### REMARKS

Applicant(s)	:	Riffiee	)	
			)	
Serial No.	:	08/800,574	)	Examiner:
			)	Lee, R.
Filed	:	February 18, 1997	)	
			)	Art Unit:
Entitled	:	NARROWBAND VIDEO CODEC	)	2613
			)	
			)

**MARKED-UP COPY OF AMENDMENTS TO THE SPECIFICATION AND CLAIMS**

FIGURE 1

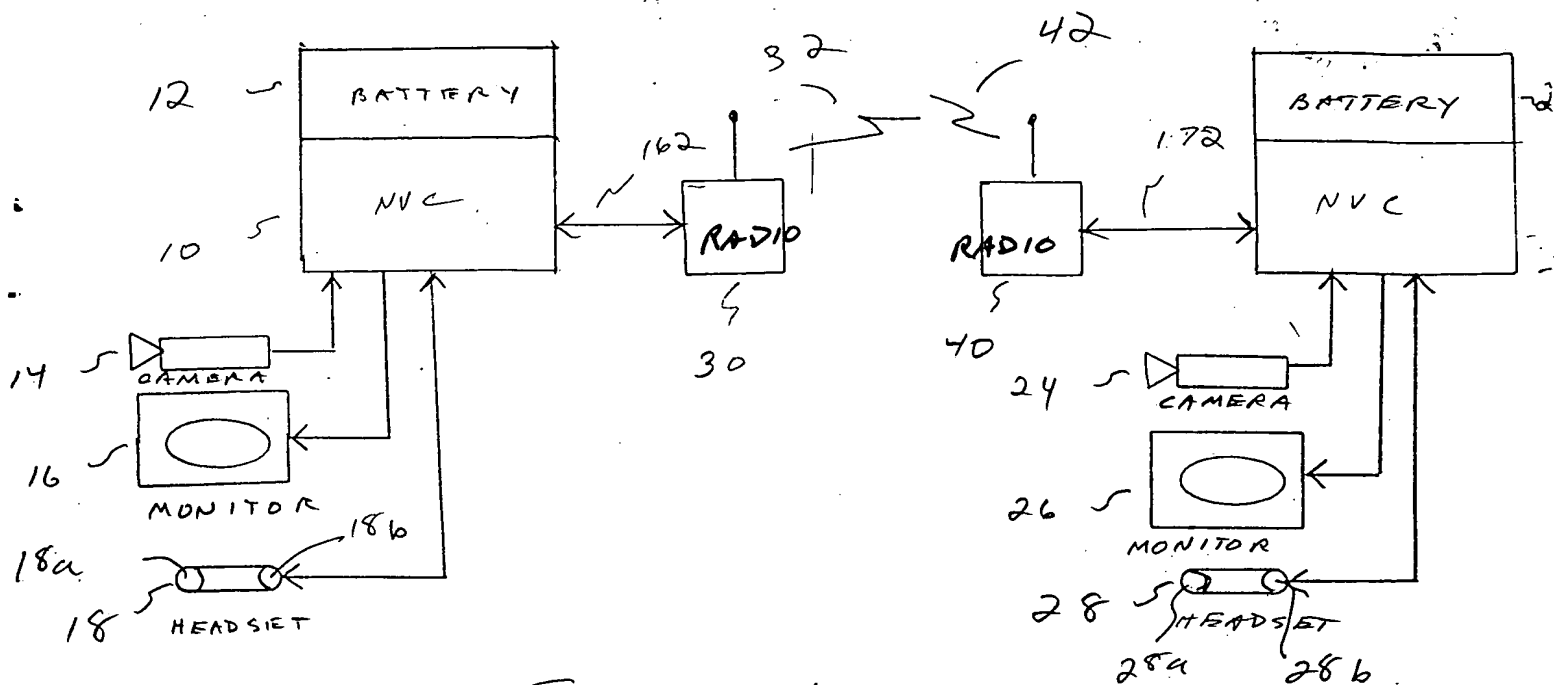
10 Responsive to the request by the Examiner to resubmit the proposed drawing changes that were submitted in response to the last Office Action, Applicant has submitted herewith a proposed Request for Drawing Change. More particularly, Figs. 1, 2 and 3C have been revised to label the diagrammatic blocks 30 and 40 of Fig. 1, blocks 14, 16, 18, 120 and 200 of Fig. 2, and block 120 of Fig. 3C so as to indicate the contents and/or function thereof, as requested by
